No.: 14 TS-15
May 1, 2014

SUBJECT: **Issues with PTO and Remote Throttle Combinations**

Note: this letter supersedes 13 TS-25

d150223

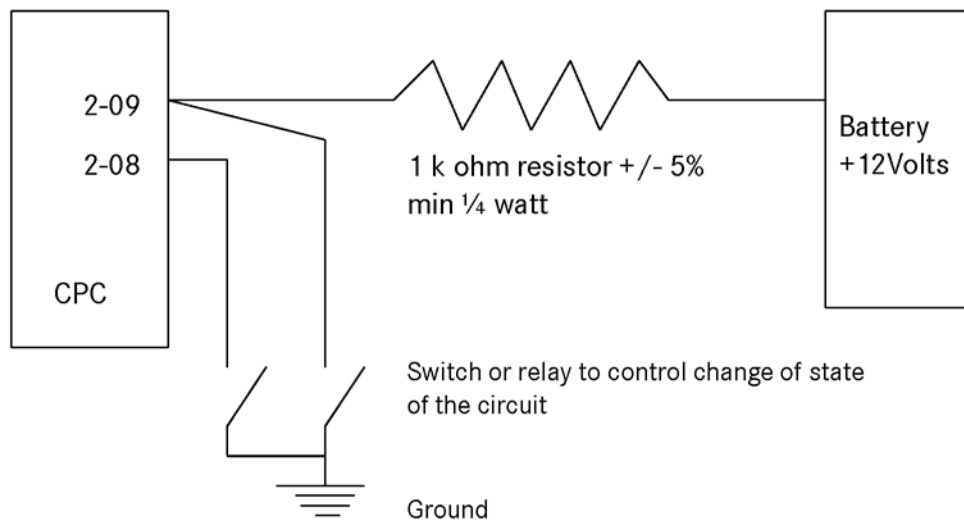
The CPC does not recognize the change of state of the digital inputs when used in hardwired configurations. Trucks with multiplex switches will not encounter this issue.

4. Be sure the wiring is correct. The inputs must be switched with a relay or switch. Hardwire of the inputs direct to ground will not function because the CPC does not see a change of state.
5. Installation of an external signal pull-up resistor is required. The external resistor should be 1000 ohm, +/-5%, minimum 1/4 watt. The resistor should be connected from CPC connector 2 pin 9 to Battery positive as shown in the sketch below.
